NUMBER 015

Fiat 1.9 JTD engines / Accessory Drive / Belt Info.

GATES REFERENCE:
6PK1835XQ & related kits.
MAKE:
MODEL:
MOTOR:
MOTOR CODE:

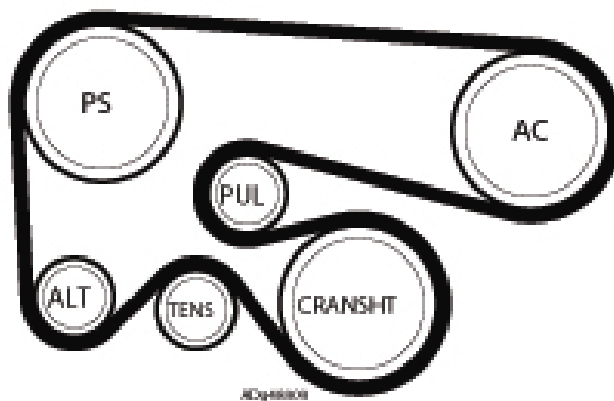
On different models from the Fiat group, equipped with the 1.9 JTD engine and air conditioning compressor in the drive, several adjustments have been made to the accessory drive system since its introduction.

Belt length, tensioner and pulleys have undergone small changes for continuous improvement on the drive performance.

This means that the 6PK1840, previously recommended for some of these applications, should no longer be installed on this 1.9 JTD + AC drive.
 For correct actual applications, please check our online catalogue.

As a result, the Fiat group now only offers 1 belt size for this drive:
 The OE/OES references are 55189679 and 71734476.
 The Gates Micro-V® replacement belt is **6PK1835XQ**.
